Applies To: 2009 TSX – ALL

Fuel Fill Door Is Hard To Open

FUEL DOOR LOCK TAB

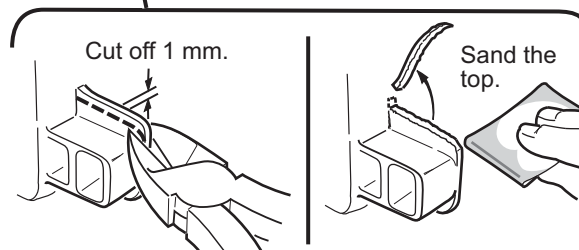
When the fuel fill door is pressed, the release latch does not disengage.

Not enough clearance in the fuel door lock tab.

1. Trim 1 mm of material from the top of the fuel door lock tab with a pair of sharp diagonal cutters.

2. Smooth the top of the tab with sandpaper or emery cloth.
